PERMIT APPLICATION FOR A RESIDENTIAL SITE
IMPROVEMENT PERMIT / CONSTRUCTION AUTHORIZATION
FOR ON-SITE WASTEWATER SYSTEM
NEW WELL INSTALLATION OR REPAIR OF EXISTING WELL
MECKLENBURG COUNTY GROUNDWATER & WASTEWATER SERVICES

IMPROVEMENT PERMIT for a RESIDENTIAL ON-SITE WASTEWATER TREATMENT & DISPOSAL SYSTEM

GWS Septic System Design Review

RE: Request for an Improvement Permit for Lot 32 at The Retreat at Latta Plantation off of Sample Road.
MCHD File #6770B

Scale: 1 inch equals 50 feet	S&ME	Faison-Sample Road, LLC	FIGURE
Drawn by: JBP		Lot 32	1
Reviewed by: Jeremy P. Michelone, RS		Mecklenburg County, NC	
Date: March, 2007	ENVIRONMENTAL SERVICES • ENGINEERING • TESTING	S&ME Project #1588-05-091

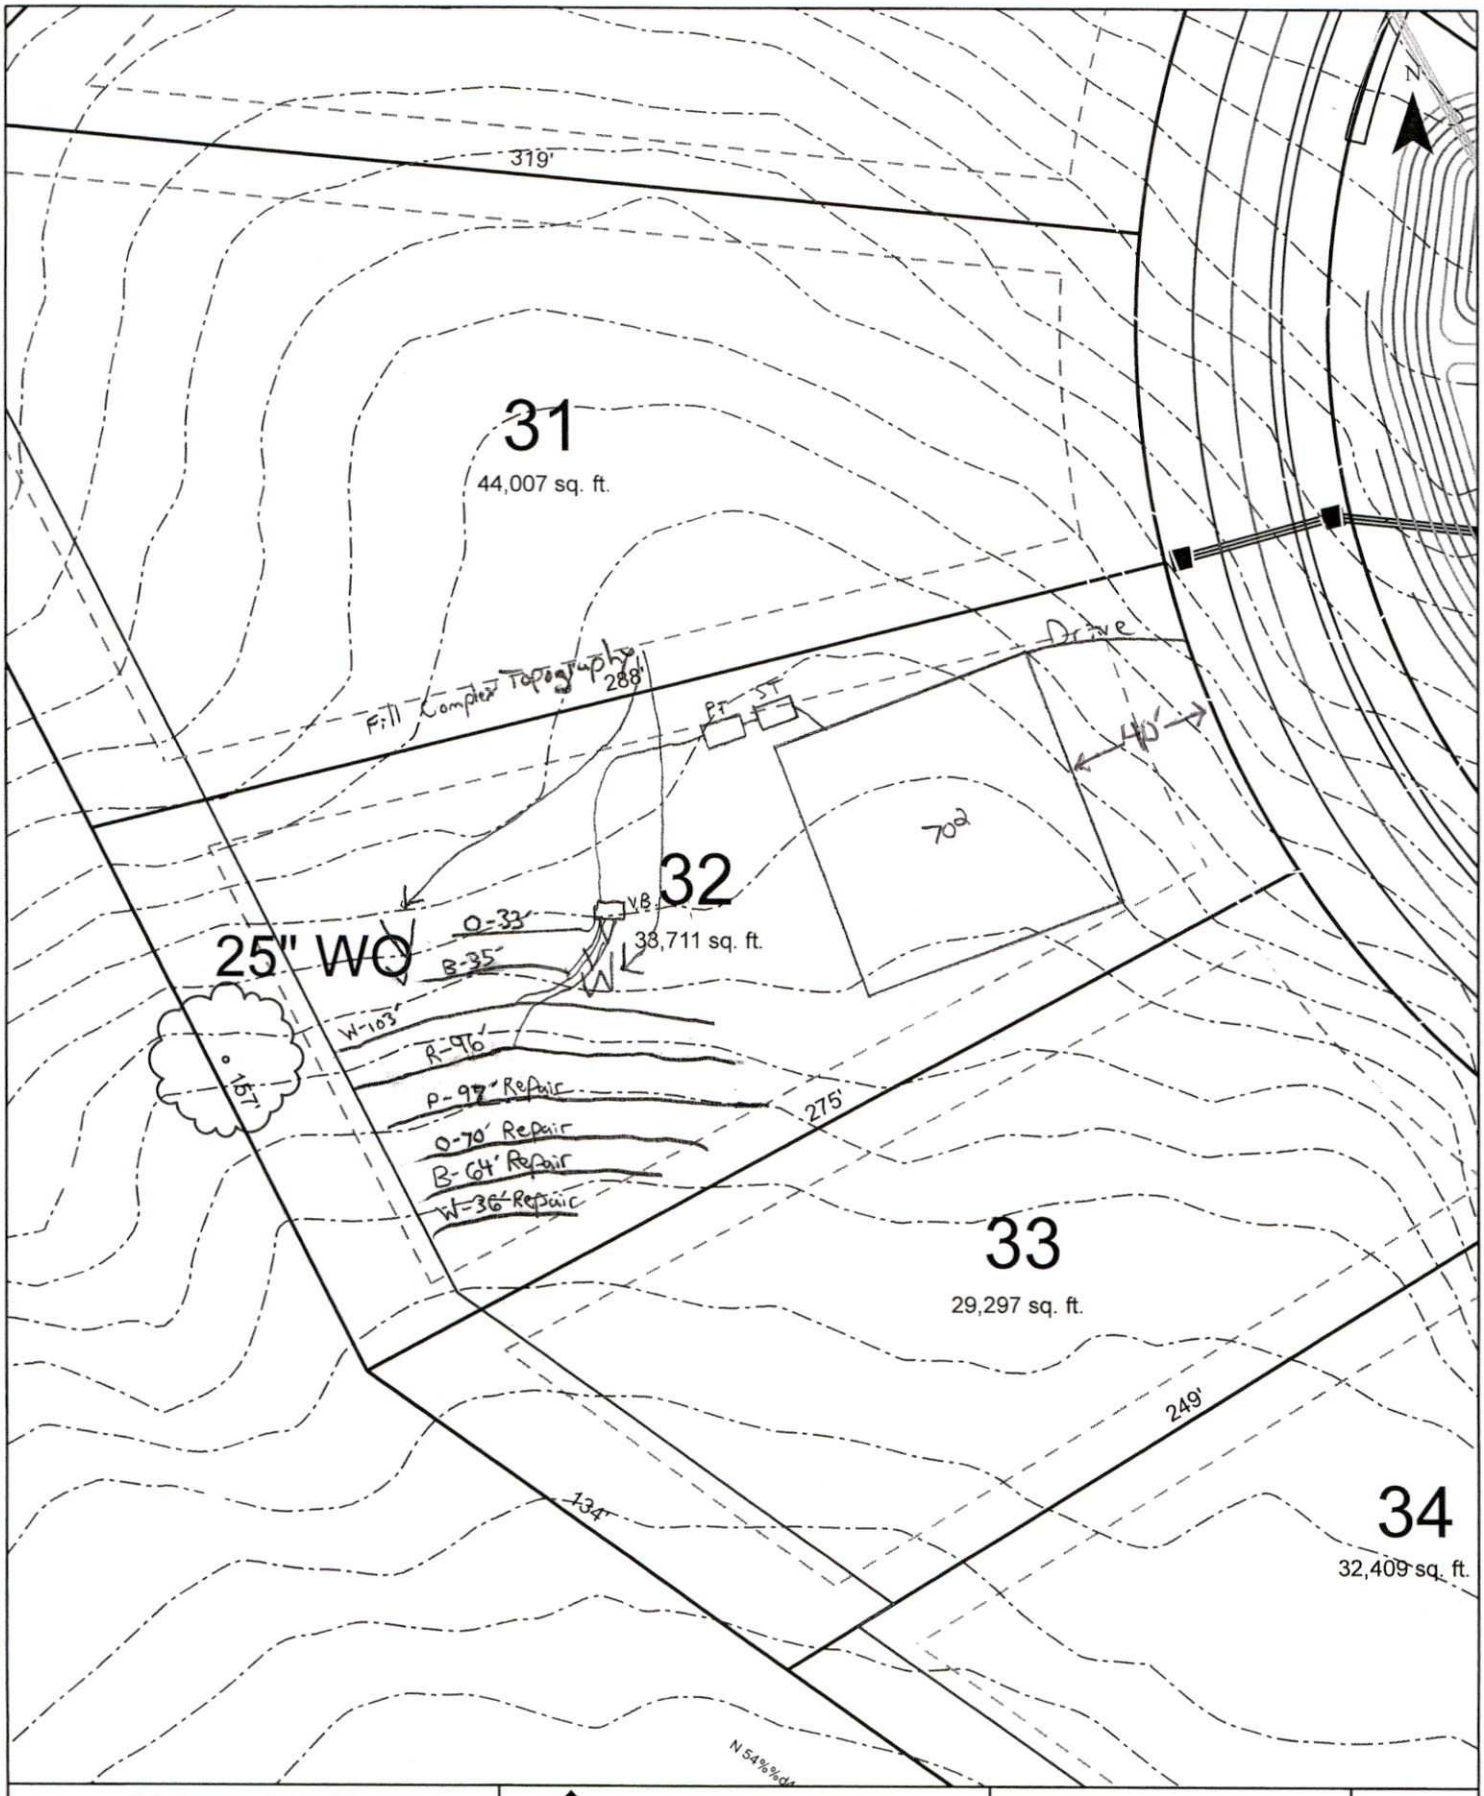
Comments:

1. Install system using 3 ft. wide trenches.
2. Install drainlines on 9 ft. centers, level, and on contour.

3. System design requires effluent pump for distribution.								
4. 100% Repair area is required.
